Manhattan Community Board 4

NYS Liquor License/DOT Dining Out Stipulations Application

Updated NYC Department of
Transportation Site Plan with Sidewalk Café
and Roadway Café Diagram

COMMUNITY BOARD FEEDBACK PACKAGE

*REVISED SITE PLAN

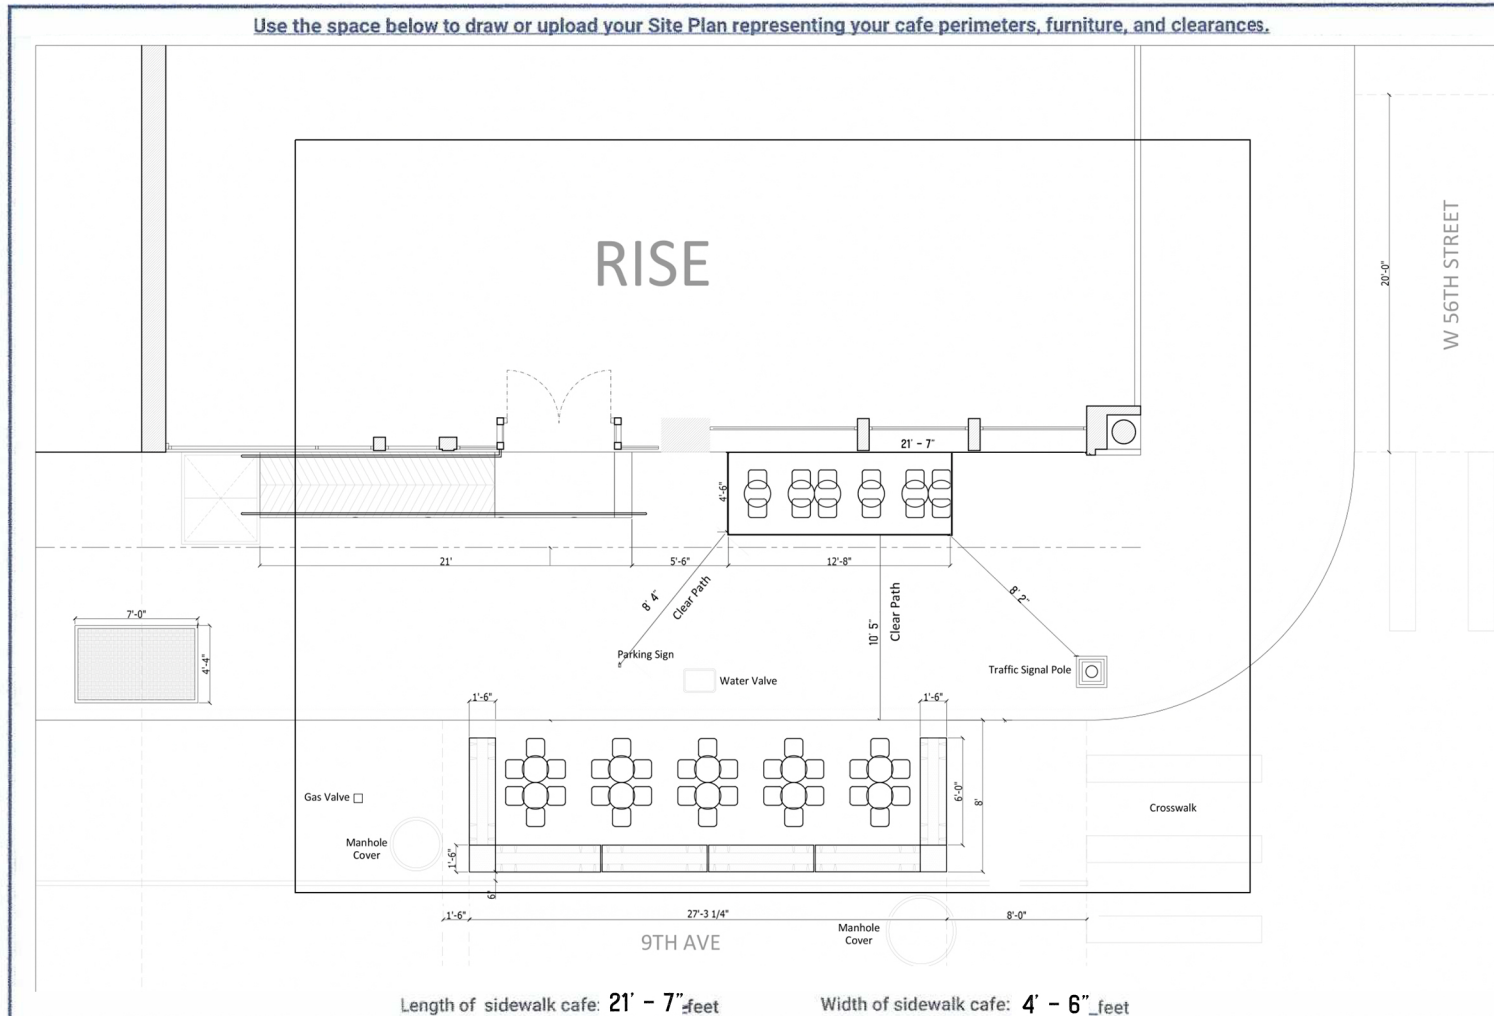
The proposed Site Plan does not provide for the required 8 foot pedestrian clear path at the north end of the cafe. The applicant has agreed to remove 1 table with 3 seats at the north end of the cafe to provide for the required clear path. See attached Revised Site Plan

To provide for the required 8 foot pedestrian clear path, MCB4 request that 1 table with 3 seats at the north end of the cafe be removed. The applicant has agreed to this change and provided the attached Revised Site Plan.

☒ Applicant acknowledges and agrees to modifications relating to the above referenced application
